# UNITED STATES PATENT AND TRADEMARK OFFICE

APPLICATION NO.	FILING DATE	FIRST NAMED INVENTOR	ATTORNEY DOCKET NO.	CONFIRMATION NO.
09/639,684	08/15/2000	Dennis H. Runnoe	14374.14	4147

# Office Action Summary

Figure 1 - U.S. Patent 5,264,801 to DeCou, Jr. et al.

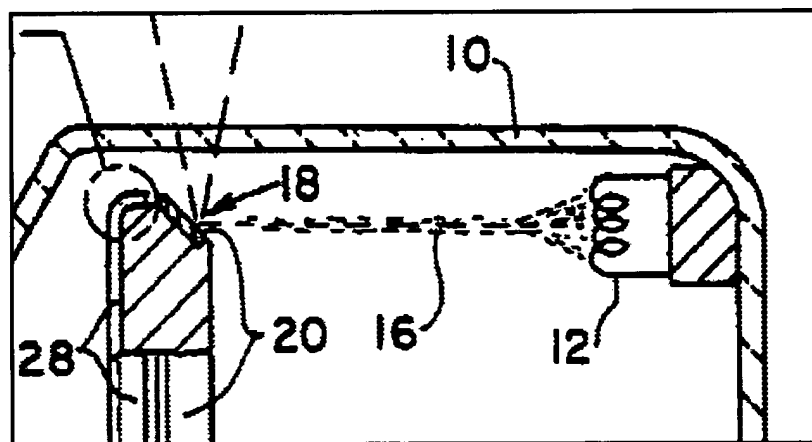
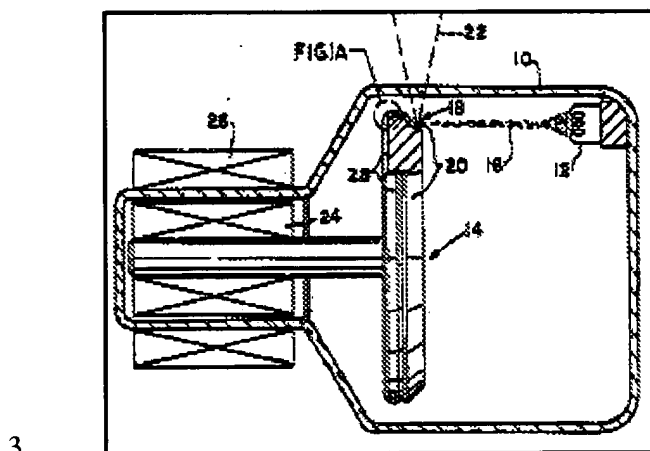
5. **As per claims 1, 5, 28, 29, 30, 44 and 53**, DeCou, Jr. et al. disclose an x-ray device, comprising:

6. (a) a vacuum enclosure (10),

7. (b) an integral cathode disposed in said vacuum enclosure (note: column 1, lines 14-15 and 17-19, column 2, lines 45-47) said integral cathode including an emitter (12) capable of discharging electrons (16), the emitter having a predetermined geometrical configuration oriented to cause some of the discharged electrons to converge to a focal spot (18);

8. (c) a power source (not shown above - however, DeCou Jr., et al. disclose the emission of electrons upon the application of DC potential - see also column 2, lines 61-65) connected to said emitter so that transmission of power from said power source to said emitter causes said emitter to discharge electrons;

9. (d) a target anode (14) disposed in said vacuum enclosure and having a target surface positioned to receive at least some of the electrons discharged by said emitter;

10. (e) a support cartridge, providing structural support for the emitter (see Fig. 1, above) and

11. (e) wherein the emitter (12) has a predetermined geometrical configuration oriented to cause at least some of the discharged electrons to converge to a focal spot (see Fig. 1, above; see also column 2, lines 61-65).

12. **As per claims 2 and 6**, DeCou, Jr. et al. disclose an x-ray device wherein the focal spot (18) is located proximate to the target surface of said target anode (14); (see Fig. 1 above).

14. As per claims 11-16, 18, 31-39, 41-43, 45-52 and 54-56 DeCou, Jr. et al. disclose an x-ray device wherein the support cartridge comprises at least one conductive portion, the electron beam and focal spot being selectively manipulated by the application of a voltage to the at least one conductive portion (i.e. Fig.1), the emitter comprises a plurality of subsidiary emitting portions integral with each other, at least two subsidiary emitting portions not being parallel to each other while cooperating to facilitate the convergence of at least some of the discharged electrons (see Fig. 1 above), wherein the at least two subsidiary portions are integral with each other and are disposed in a substantially "V" shaped configuration (see also Fig. 1 above); wherein a plurality of cut out portions are defined in the emitter, the plurality of cutout portions collectively defining an electrical current path; the emitter substantially comprises a single piece of emissive material, at least one of a subsidiary emitting portion is substantially planar, at least one of a subsidiary emitting portions substantially comprise a geometry selected from the group consisting of parabolic and spherical sections (see Fig. 1 above and respective portions of the specification).

Figure 2 - U.S. Patent 5,264,801 to DeCou, Jr. et al.

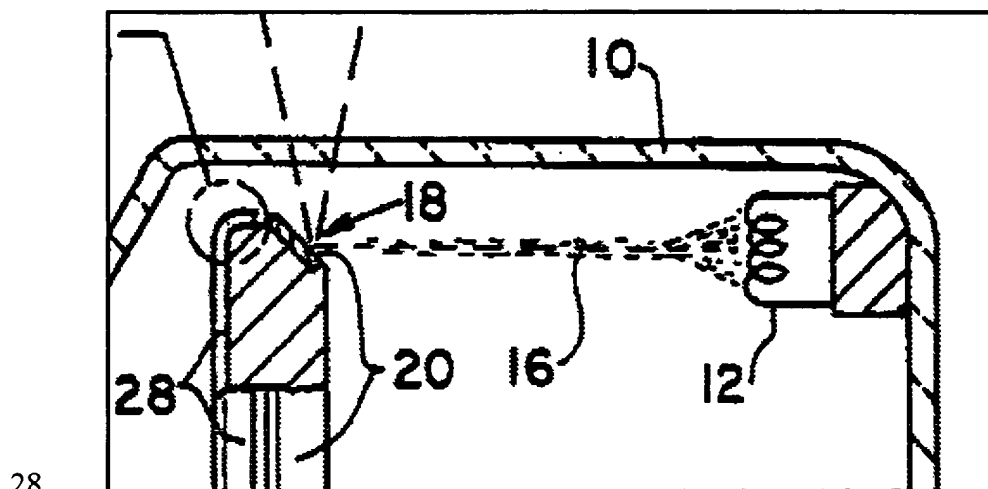
30. In particular, DeCou Jr., et al. (U.S. Patent 5,264,801) disclose an X-ray device comprising a vacuum enclosure (10), an integral cathode having an emitter (12), the emitter having a predetermined geometrical configuration oriented to cause at least some of the discharged electrons (16) to converge to a focal spot (18), a power supply (not shown above - DeCou Jr., et al. disclose the emission of electrons upon the application of DC potential - see

also column 2, lines 61-65), and a target anode (14) (Examiner notes that numeral 14 is not visible in the enlarged portion of Fig. 1 above) disposed in the vacuum enclosure (10) and having a target surface (20) positioned to receive at least some of the electrons (16) discharged by the emitter (12).

32. Examiner believes however, DeCou Jr., et al. (Patent '801) rightly meets the requirements for a 35 USC 102b rejection, since every element set forth in the claim is found, either expressly or inherently (compare claim language to DeCou Jr., et al. Fig. 1 above). Furthermore, Examiner has applied procedures commensurate with MPEP 2111 and 2111.01 during the examination of the current application and has concluded that the apparatus of DeCou Jr., et al. anticipates Applicants invention as claimed, including the limitation of an emitter having a predetermined geometrical configuration oriented to cause at least some of the discharged electrons to converge to a focal spot, since this feature is readily seen in Fig.1 of DeCou Jr. et al (see above).

33. Based on the above, Examiner concludes that Applicants arguments are not persuasive, since DeCou Jr. et al. meet every element set forth in the pending independent claims, including the limitation of an emitter having a predetermined geometrical configuration oriented to cause at least some of the discharged electrons to converge to a focal spot.
